ADDENDUM NO. 1

**RE: City of Dublin
Dublin Community Recreation Center
Geothermal Project
Dublin, Ohio
PEA-13390**

Date: December 18, 2014

**PARTIAL COURTYARD
HVAC PLAN**
 SCALE: 1/4" = 1'-0"

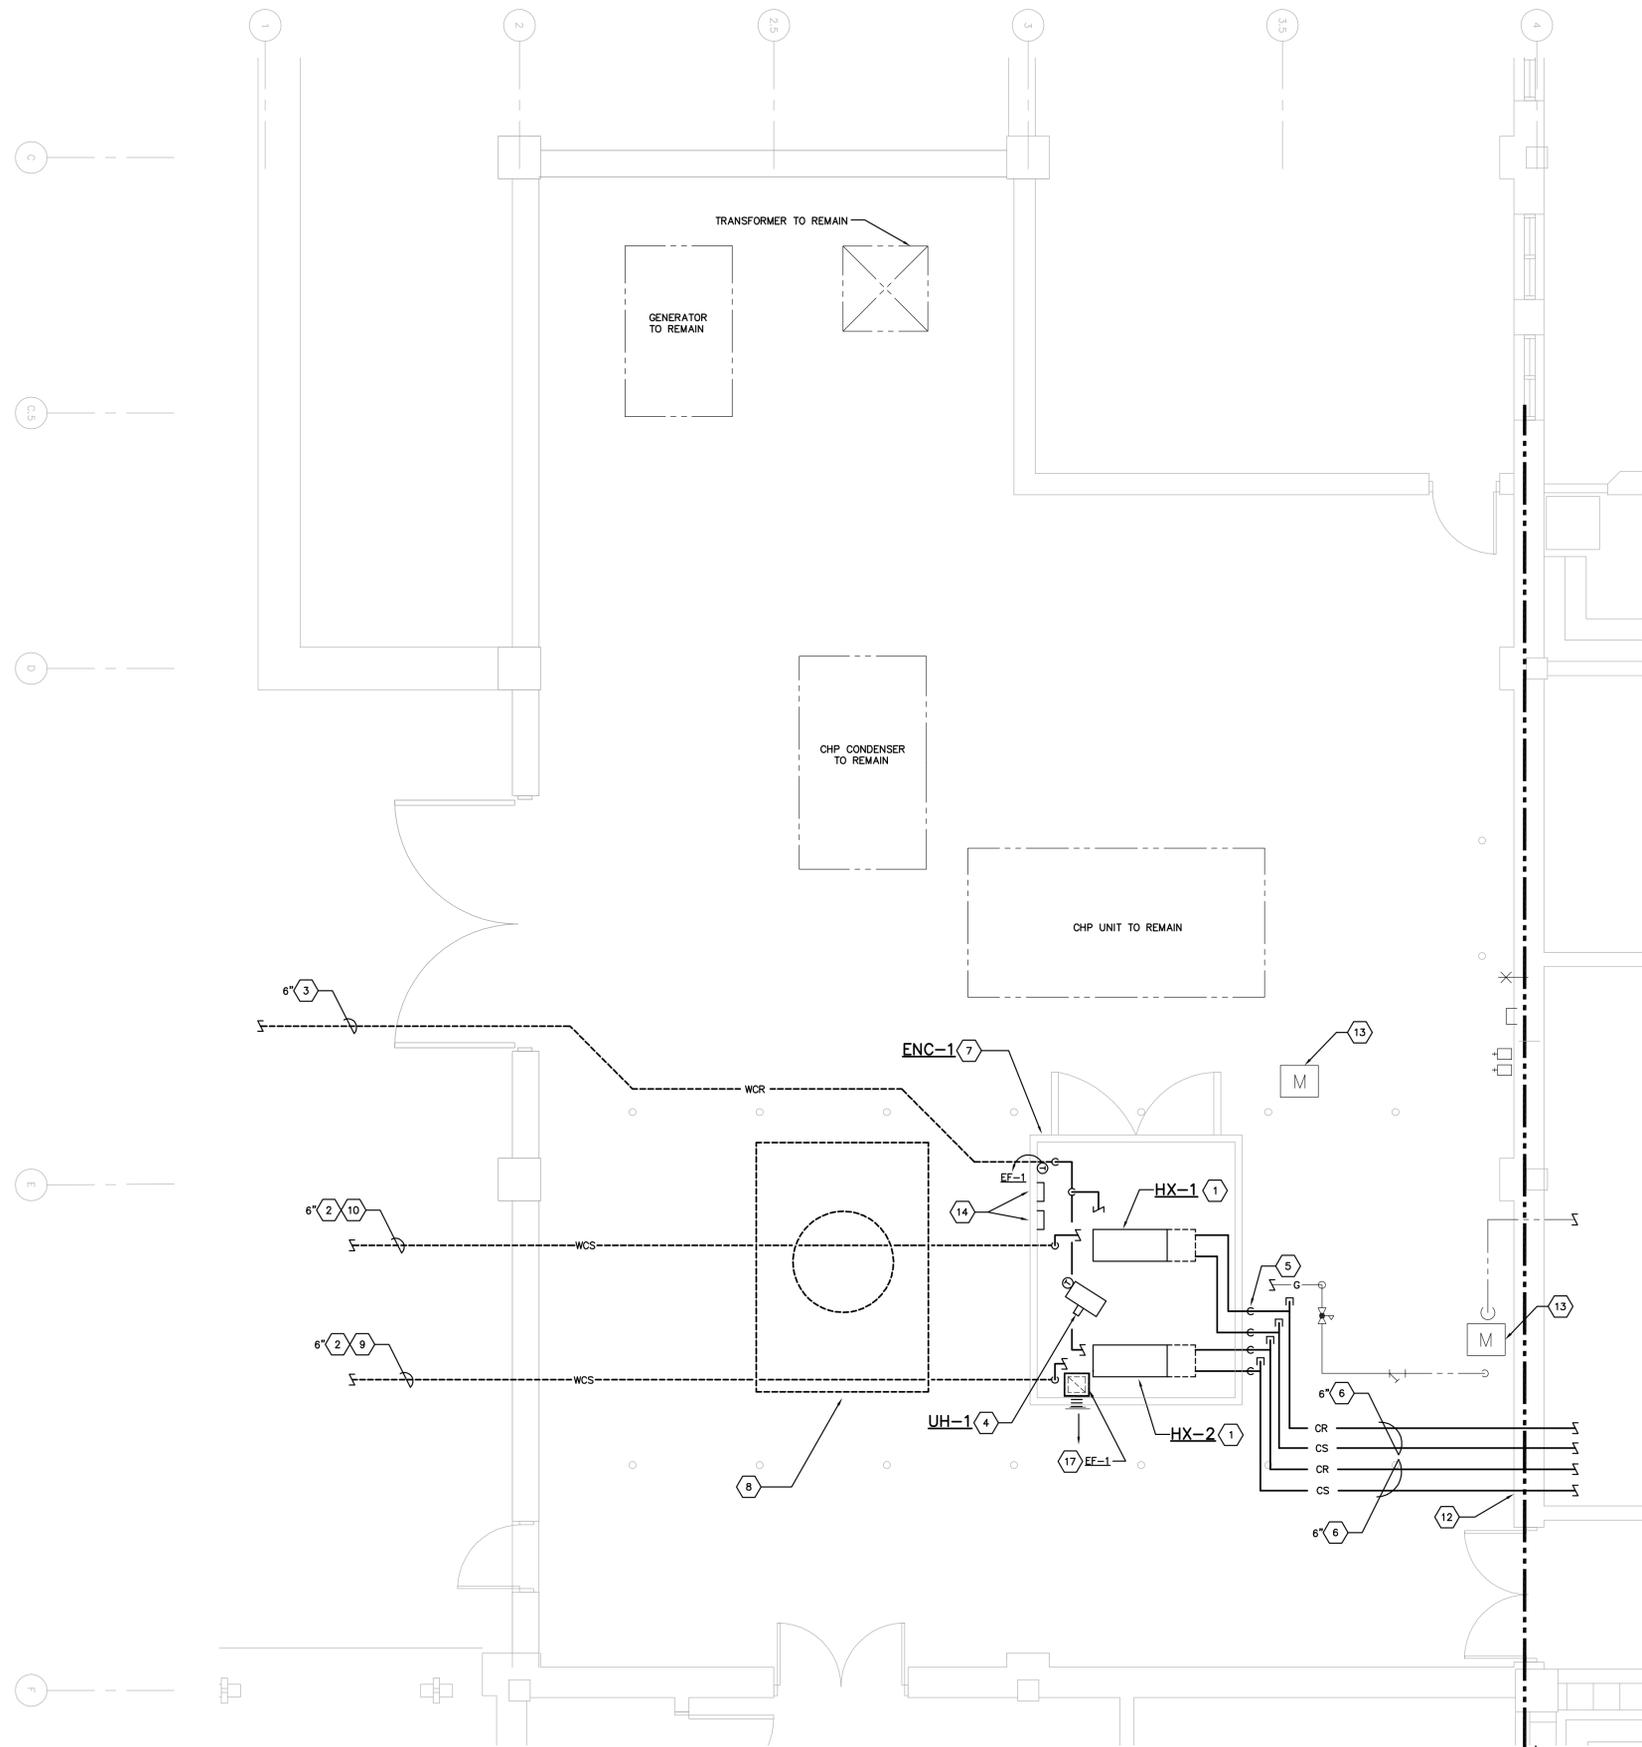
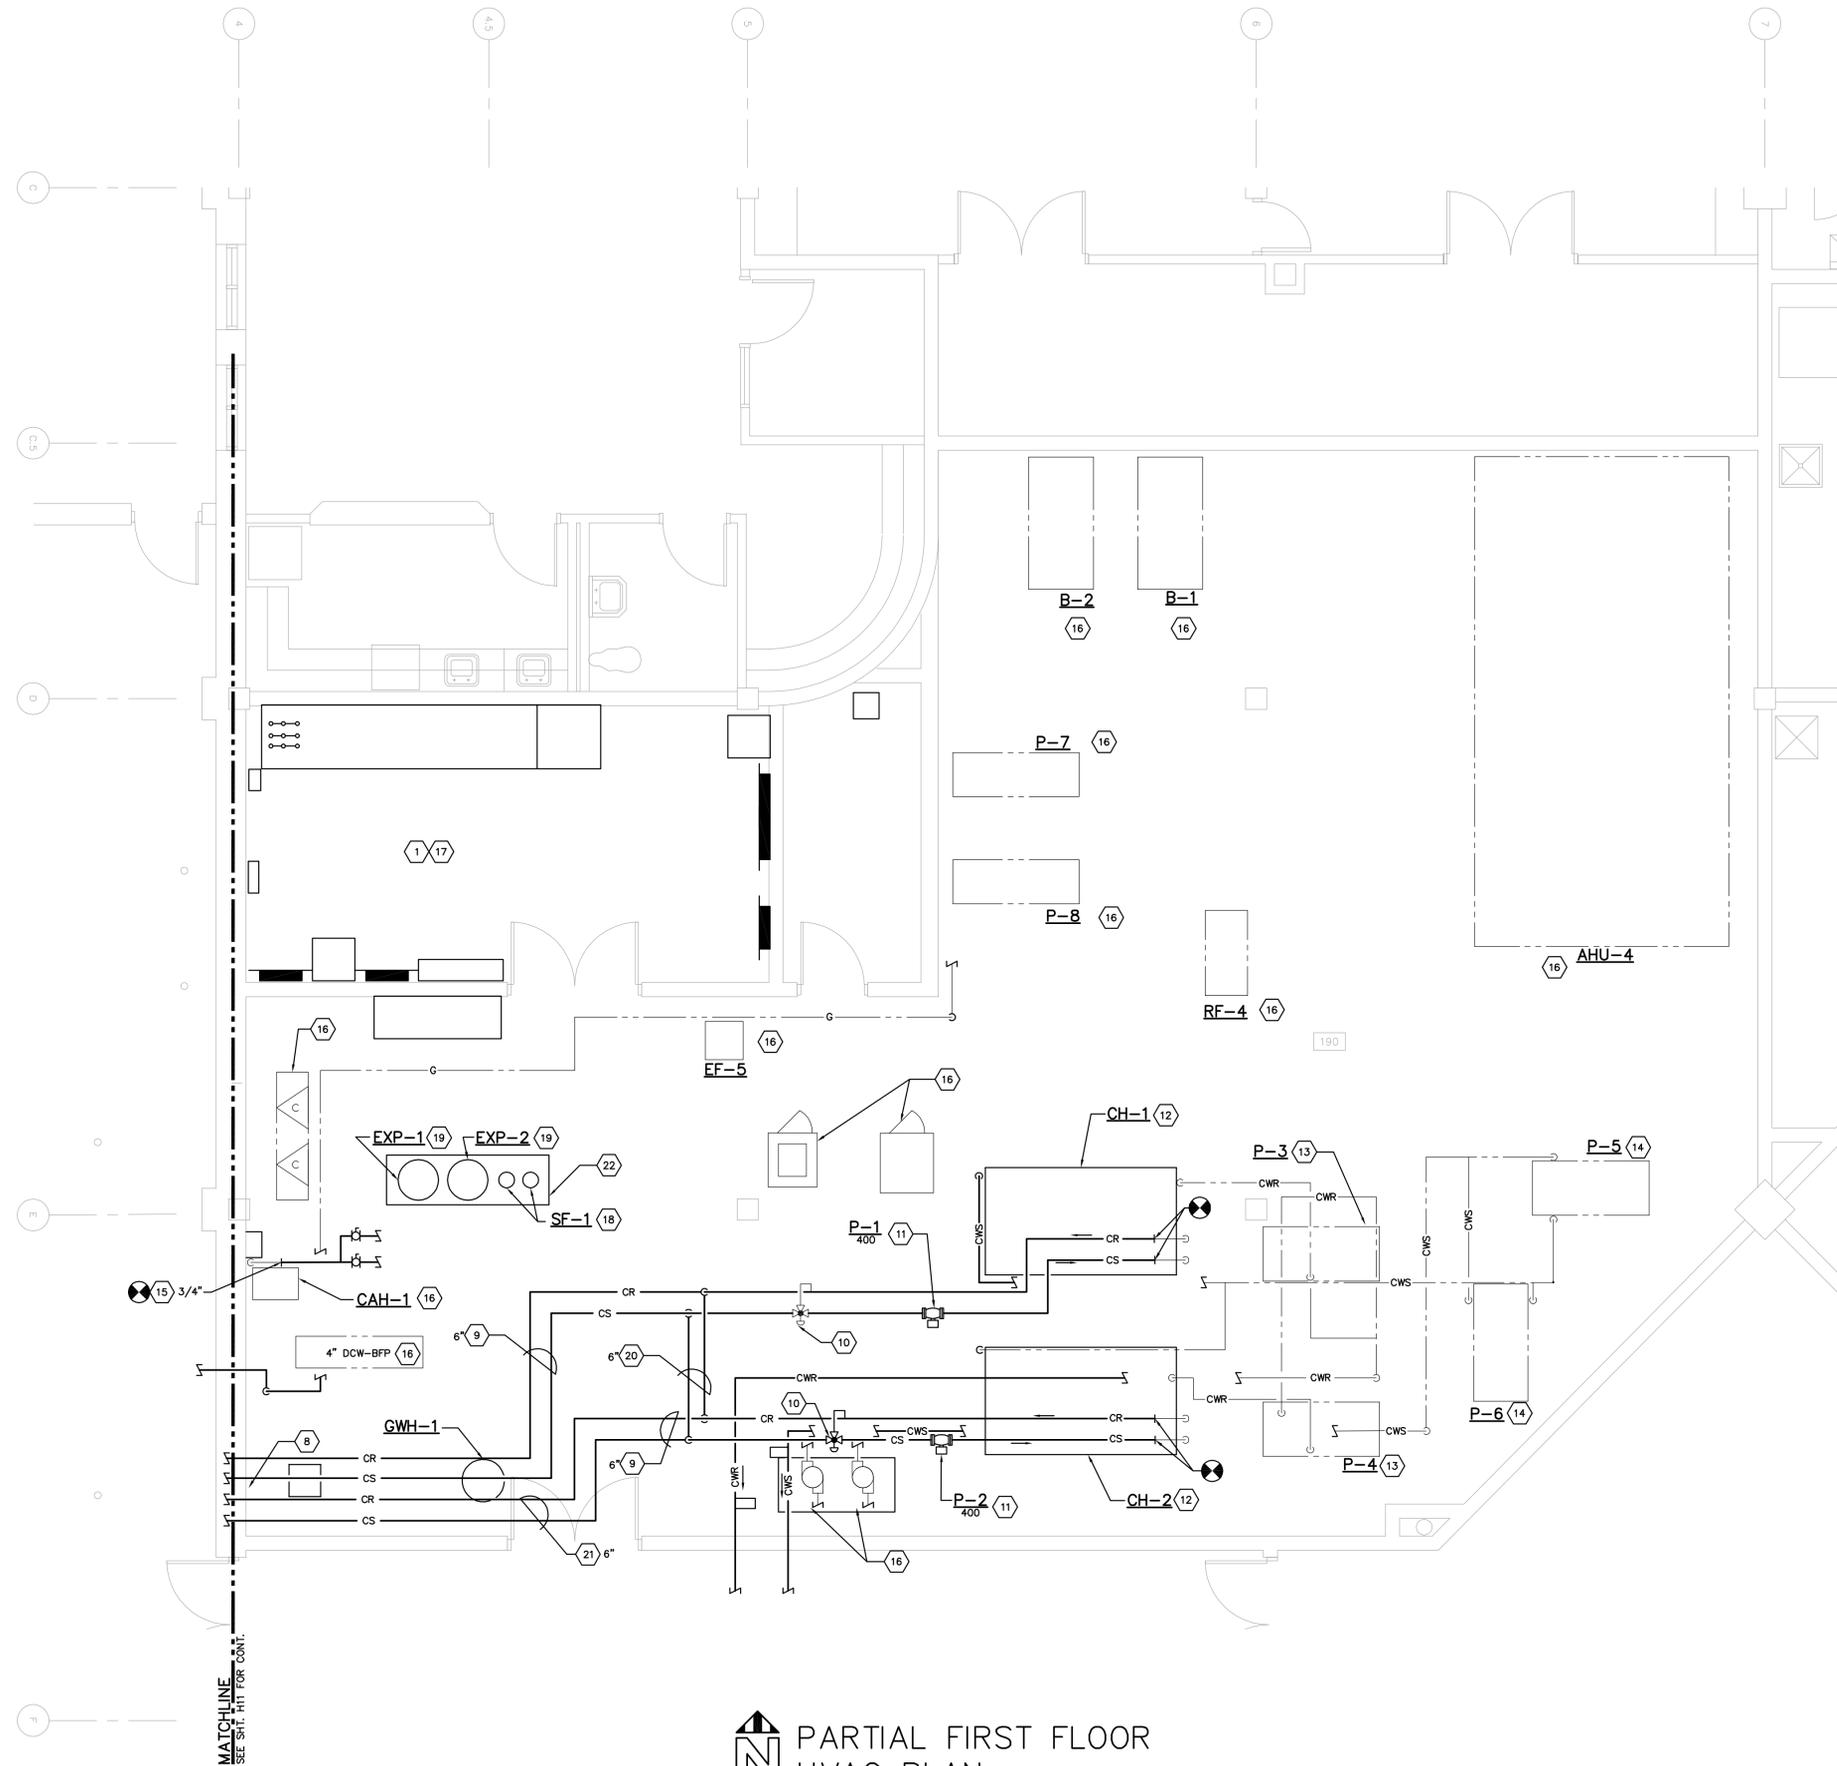
- A. Replace the bid sheet with the attached. Base bid scope is defined as one run of 6" directional bore piping, with Alternate 1 scope to provide two runs of directional bore piping. Basket strainers were added to the inlet of the heat exchangers.
- B. Base bid scope is defined as one common run of condenser water piping between the heat exchangers and the chillers, with Alternate 2 scope to provide two separate condenser water loops.

1. NEW GEOTHERMAL WELL WATER TO CONDENSER WATER HEAT EXCHANGER IN HEATED ENCLOSURE. PROVIDE BASKET STRAINER ON INLET TO HEAT EXCHANGER FROM WELL SYSTEM. SEE SCHEMATIC PIPING DIAGRAMS.

9. **BASE BID:** PROVIDE SINGLE RUN OF DIRECTIONAL BORE PIPE FROM **WP-2** LOCATION TO HEAT EXCHANGERS AT **ENC-1**.
10. **ALTERNATE 1:** PROVIDE SEPERATE RUN OF DIRECTIONAL BORE PIPE FROM **WP-1** AND **WP-2** LOCATION TO EACH HEAT EXCHANGER AT **ENC-1**.

13. GAS METER AND PIPING TO REMAIN.
14. COORDINATE **WP-1** AND **WP-2** VARIABLE FREQUENCY DRIVE LOCATIONS IN ENCLOSURE WITH OTHER EQUIPMENT.
15. **BASE BID:** PROVIDE SINGLE RUN OF CONDENSER WATER SUPPLY AND RETURN PIPING BETWEEN HEAT EXCHANGERS AND CHILLERS, AND CONNECT TO HEAT EXCHANGER USING A COMMON HEADER. SEE PIPING DETAILS.

16. **ALTERNATE 2:** PROVIDE SEPERATE CONDENSER PIPE LOOPS FROM EACH CHILLER TO EACH HEAT EXCHANGER. SEE PIPING DETAILS.

**PARTIAL FIRST FLOOR
HVAC PLAN**
SCALE: 1/4"=1'-0"

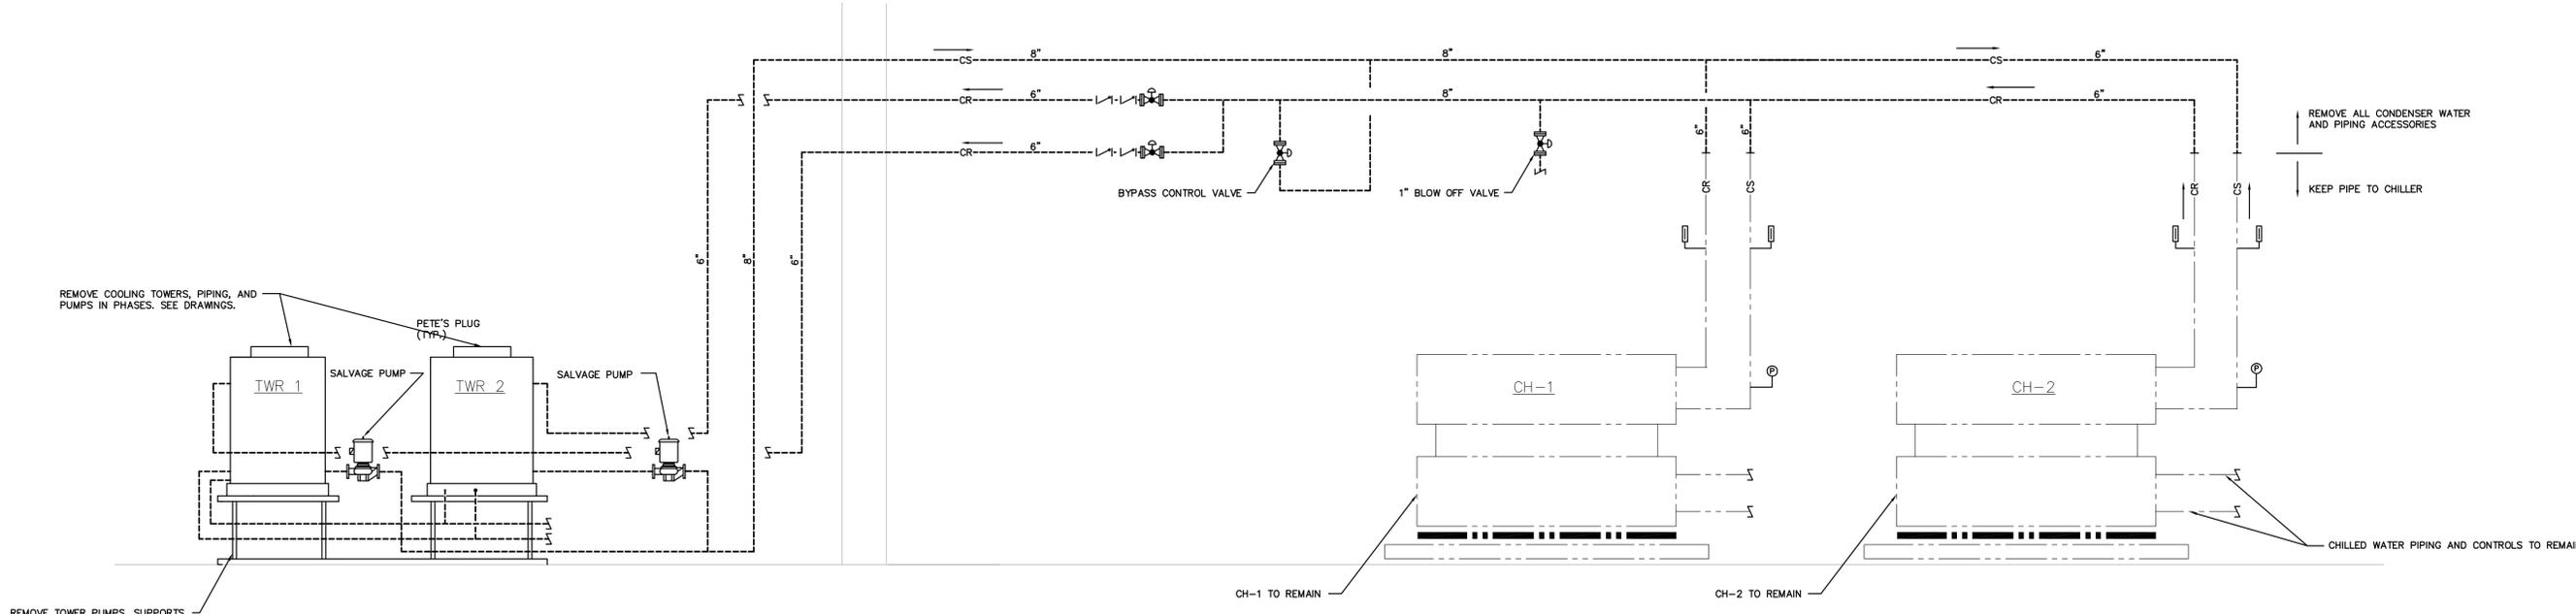
- A. Base bid scope is defined as one common run of condenser water piping between the heat exchangers and the chillers, with Alternate 2 scope to provide two separate condenser water loops. Expansion tanks, shot feeders, and make-up water scope were clarified.

16. EXISTING EQUIPMENT AND PIPING IN MECHANICAL ROOM TO REMAIN UNLESS OTHERWISE NOTED.
17. ELECTRICAL SERVICE TO REMAIN. SEE ELECTRICAL DRAWINGS.
18. PROVIDE SHOT FEEDER FOR PIPE LOOP. SEE PIPING DIAGRAM. UNDER BASE BID, ONE SHOT FEEDER IS REQUIRED. UNDER ALTERNATE 2, PROVIDE TWO SHOT FEEDERS.

19. PROVIDE EXPANSION TANK FOR PIPE LOOP. SEE PIPING DIAGRAM. UNDER BASE BID, ONE EXPANSION TANK IS REQUIRED. UNDER ALTERNATE 2, PROVIDE TWO EXPANSION TANKS.

20. BASE BID: PROVIDE SINGLE RUN OF CONDENSER PIPE FROM CHILLERS TO HEAT EXCHANGERS, WITH SINGLE EXPANSION TANK, SINGLE SHOT FEEDER AND SINGLE MAKE-UP WATER CONNECTION.

21. ALTERNATE 2: PROVIDE SEPARATE PIPE RUNS BETWEEN CHILLER AND HEAT EXCHANGERS, WITH SEPARATE EXPANSION TANKS, SEPARATE SHOT FEEDERS, AND SEPARATE MAKE-UP CONNECTIONS FOR EACH PIPE LOOP.
